PLANNING AND DEVELOPMENT COMMITTEE 16 DECEMBER 2021

2. 21/00356/FPM - LAND TO THE WEST OF STEVENAGE

ADDENDUM REPORT

Reference	21/00356/FPM		
ADDENDUM INFORMATION

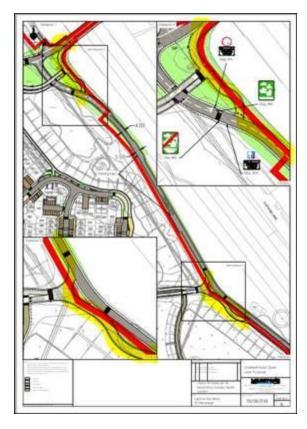
The Hertfordshire County Council's CRoW Service understand the physical constraints at Chadwell Road and accept that 'Quiet Lane' status at this location is a reasonable compromise. It must be noted however, that all vulnerable non-motorised users will habitually get off-road at the earliest opportunity, i.e. the 2 short sections of off-road provision shown in the attached plans (19206-036-RevB) will be accessed by equestrians and this must be allowed and catered for legally.

I attach a screen-grab with the desire lines highlighted that will inevitably be used:

This is easily achieved through acceptance of these short routes as multi-user status, signed with the blue Cycle+Ped+Horse signs from the TSRGD 2016 / Signs Manual; "Figure 11-19 Diagram 956.1 (S3-2-30) Route for use by pedal cycles, horses and pedestrians only".
